Applicant: G. T. Mork and Company (Case 8440A&B-79)

Location: 7900 Cedar Avenue

Request: A) Face new and existing walls of existing building with stucco rather than brick and block

Case 8810A-80

— LOCATION FOR REQUESTED USE
OF ARCHITECTURAL CONCRETE
MASONRY UNITS.

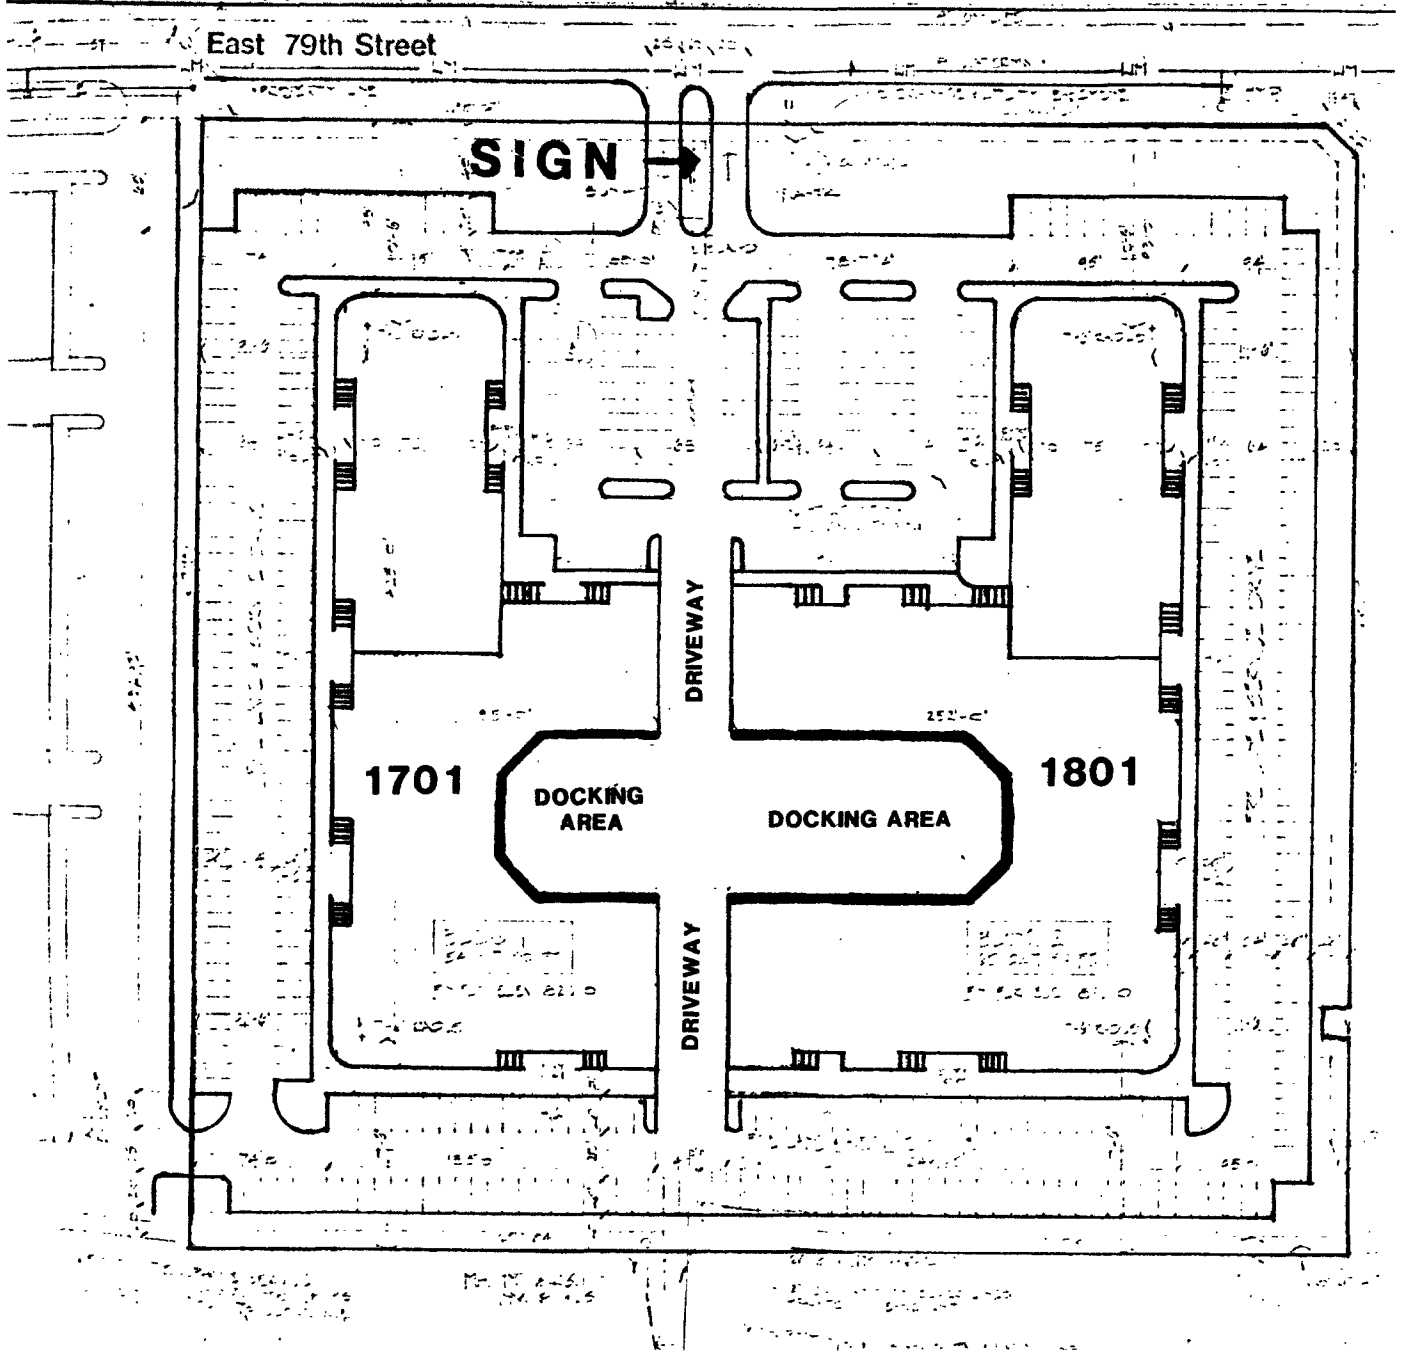
The applicant proposes to face the truck docking
areas with embossed architectural concrete
masonry units

- 1) that the material used be 8-inch by 16-inch brick textured concrete block units, to be painted a color that matches or is compatible with the face brick on the two structures;
- 2) that the use of the approved architectural concrete masonry units is restricted to those walls forming the perimeter of the two docking areas and is not to extend onto any walls abutting the interior drive nor any other portion of the buildings.

SIGN DETAIL
SCALE 1/2" = 1'-0"

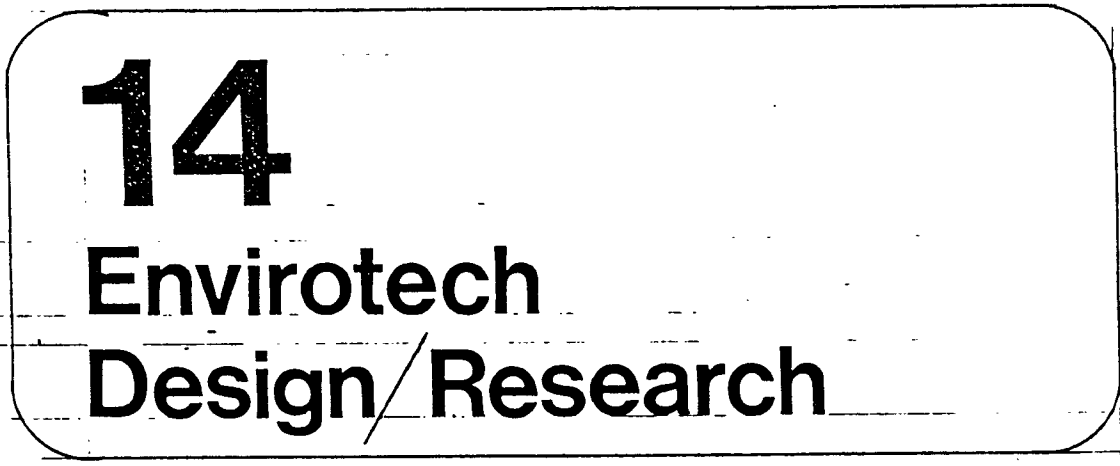
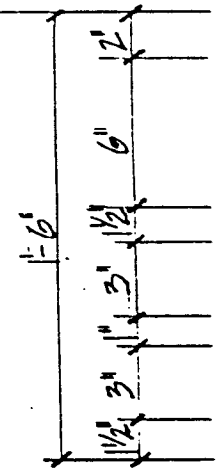
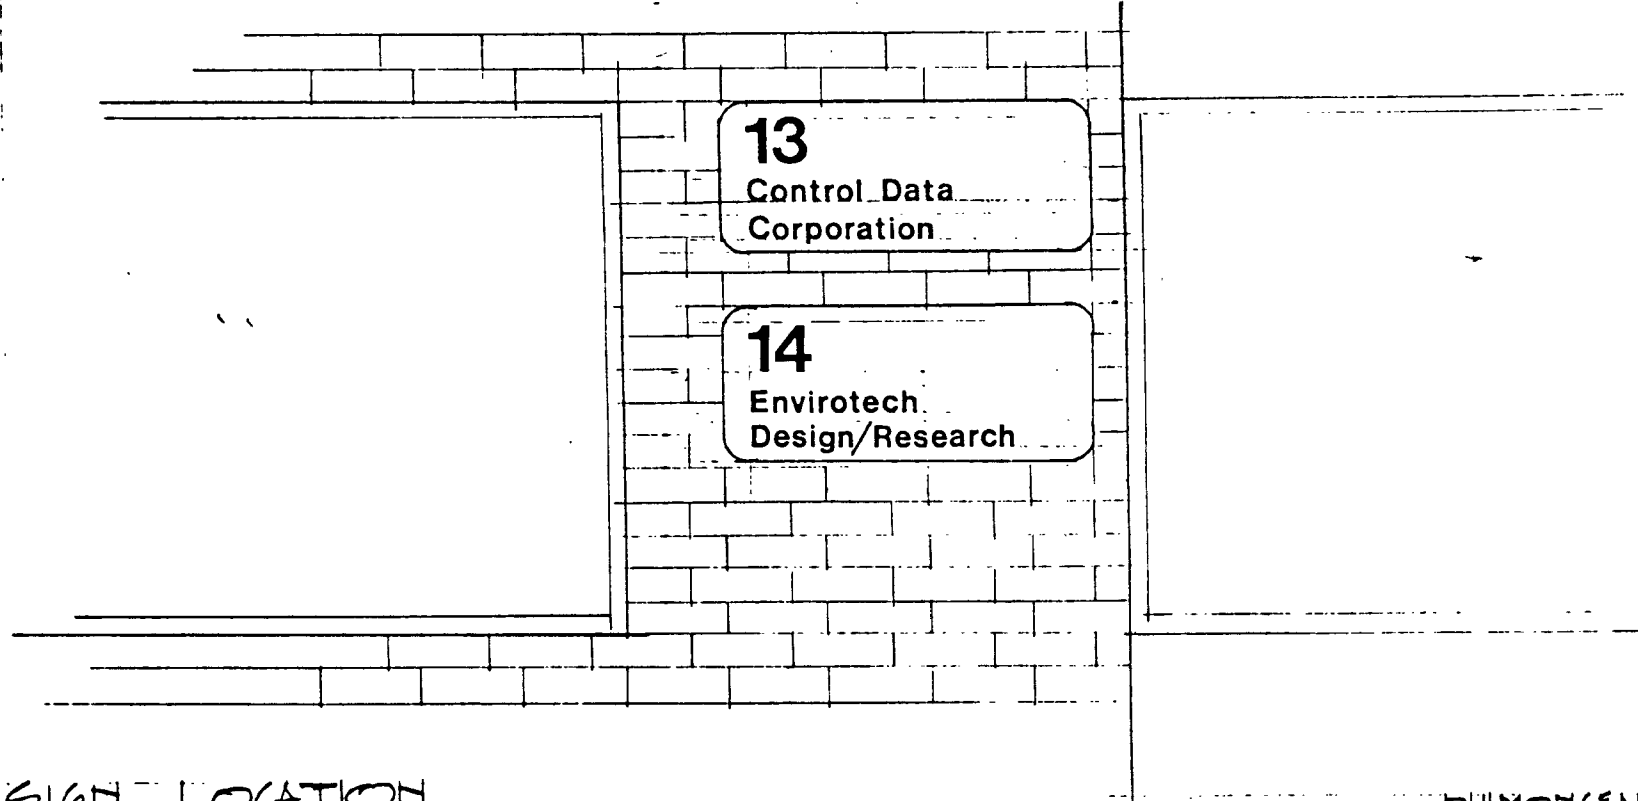
The four-foot by 12-foot sign would set atop a two-foot three-inch high brick planter in the entry island. The project name would be set out on both faces with freestanding letters of less than 12 inches high.

Staff would note that the master sight plan and planter/sign detail do not match up and that the former shows a 24-foot setback while the latter shows a 34-foot setback. These discrepancies should be corrected by the applicant.

- 1) sign size not to exceed four feet by 12 feet;
- 2) brick and letters to be approved by the Director of Planning; and
- 3) overall sign design for the development be approved by the Manager of Building and Inspection Division.
